# STAFF REPORT

Community Planning and Preservation Commission Certificate of Appropriateness Request

Case No.: 21-90200099

Address: 1001 Bay Street Northeast

Figure 2: Proposed fence style for front yard.

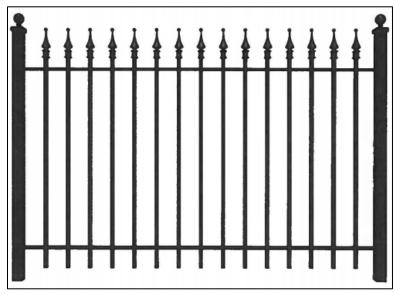
Front fences were not a typical feature in St. Petersburg, but the proposed front fence will be traditional in design, as it will be a dark metal finish and three feet in height. Due to its design, the front fence will be very transparent and won't have a large visual impact on the district.

The proposal will include a front fence, which is not a traditional feature for the historic district. Other front fences have been approved in this district recently, and this front fence will be made of traditional materials and will have a high level of transparency.

Figure 2: Proposed north elevation of garage, with the areas to be altered highlighted in blue.

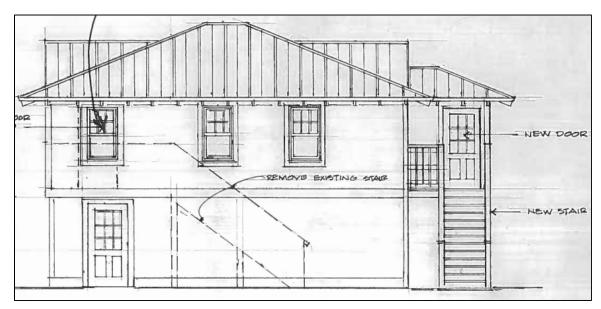
The relocation of the stairs on the rear garage apartment does change the historic location of the stair, as evidence by the 1923 Sanborn map. Staff does not believe the location of the exterior staircase is a character defining feature for this property.

EXISTING EAST ELEVATION

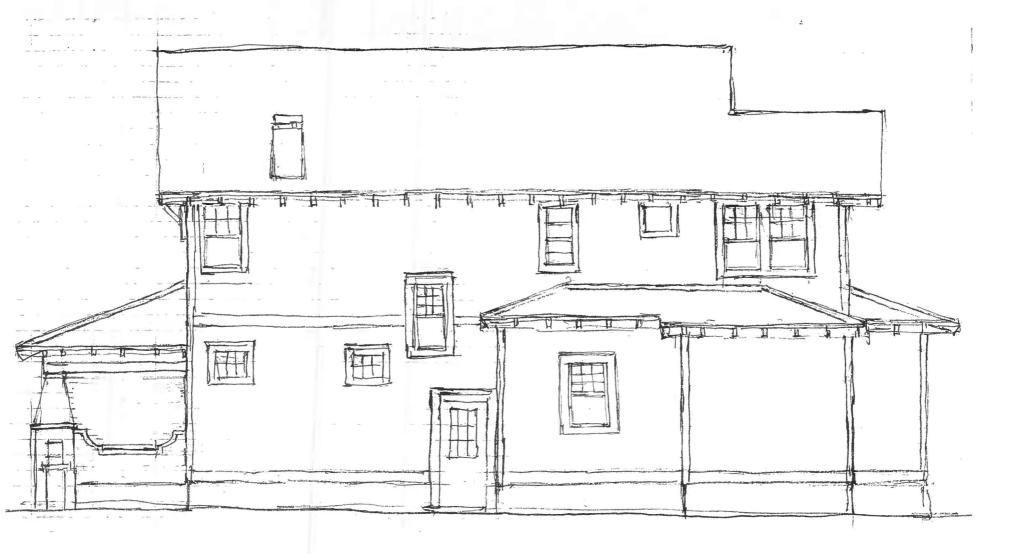
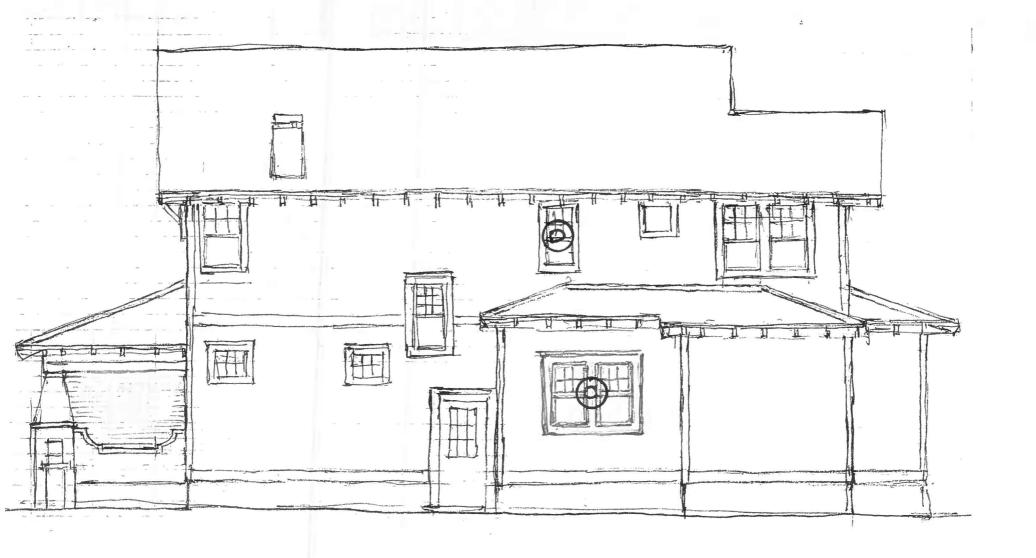
Most of the windows will replace the existing fenestration opening. There is one window (Window C on the plan) on the east elevation that will be replaced with two paired windows to allow in more light. Window C is located on a non-publicly visible elevation, and set towards the rear. Staff does not find the proposal to be detrimental to the character of the house because of the location of the window.

- 1. Wooden exterior casing and trim will be reinstalled in kind.
- 2. Windows will be installed to be setback within the wall plane and feature a reveal of at least two inches, to match existing window reveal.
- 3. A historic preservation final inspection will be required.
- 4. All other necessary permits shall be obtained. Any additional work shall be presented to staff for determination of the necessity of additional COA approval.
- 5. This approval will be valid for 24 months from the date of this hearing, with an expiration date of September 14, 2023.
